Re: Cielito Lindo
5109 Central NW
Traffic Circulation Layout
Architect's Stamp dated 12-05-16 (K11-D085)

The TCL submittal received 12-07-16 is approved for Building Permit. A copy of the stamped and signed plan will be needed for each of the building permit plans. Please keep the original to be used for certification of the site for final C.O. for Transportation.

Based upon the information provided in your submittal received 11-18-16, the above referenced plan cannot be approved for Building Permit until the following comments are addressed:

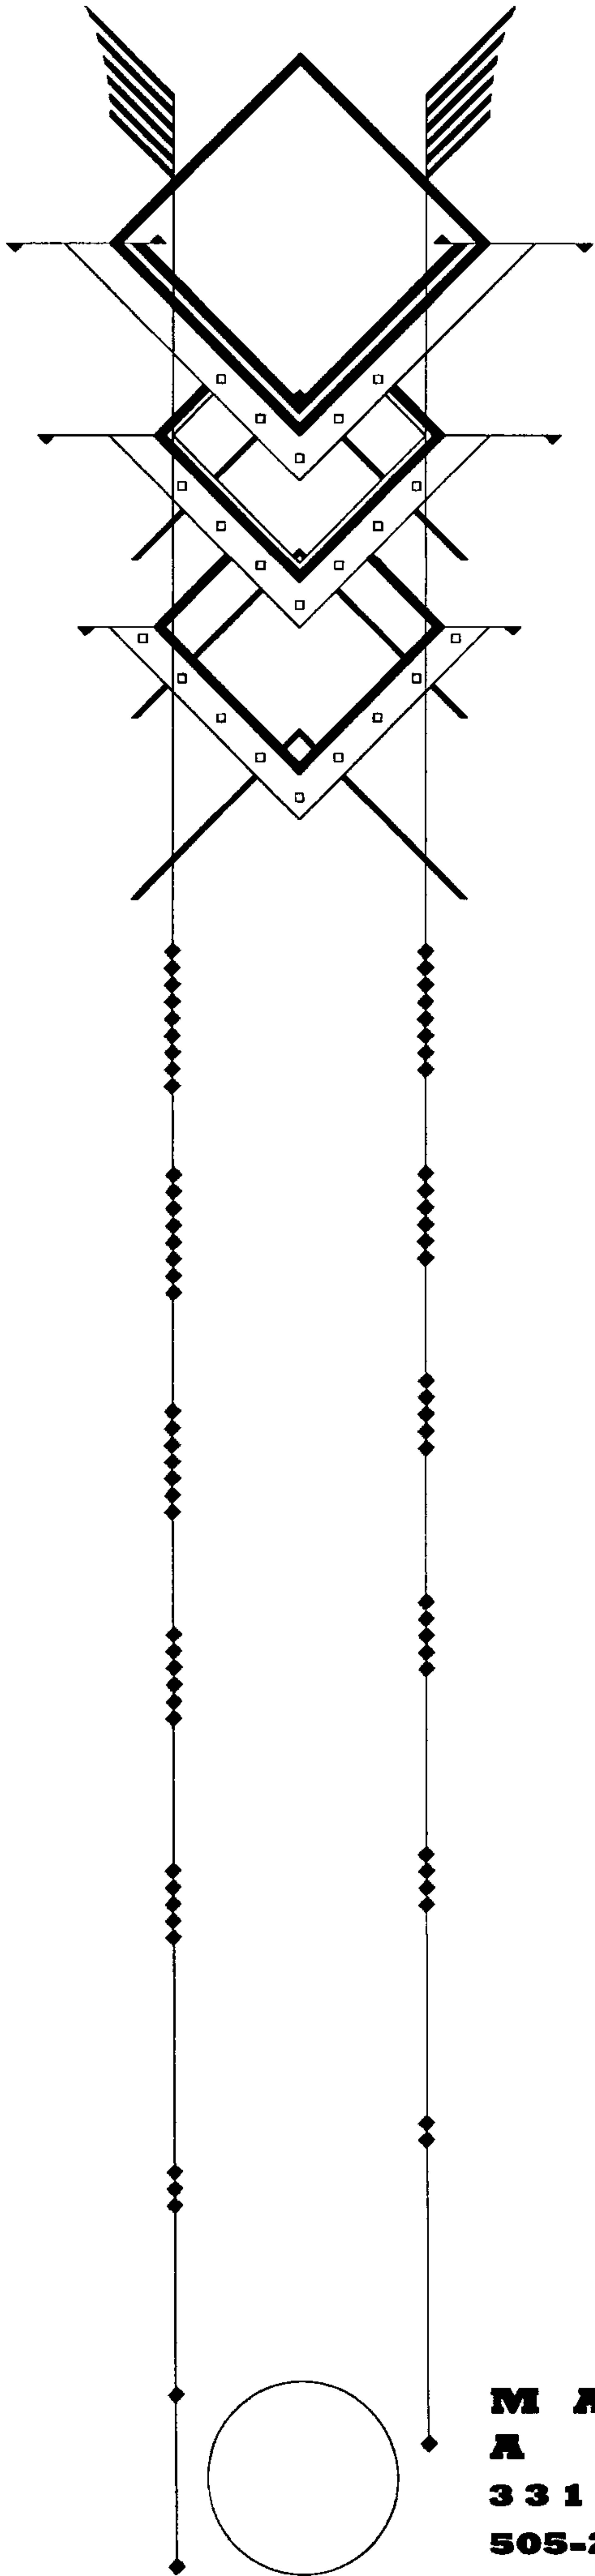
The parking stalls are still short in length. The you may want to consider extending aisle and reduce the entrance.

The 35 degree angle parking should be about 17' 4" per DPM Figure 23.7.1.

The 30 degree angle should be 16' 5". This is all with an 18 foot aisle. You are showing 16' on both.
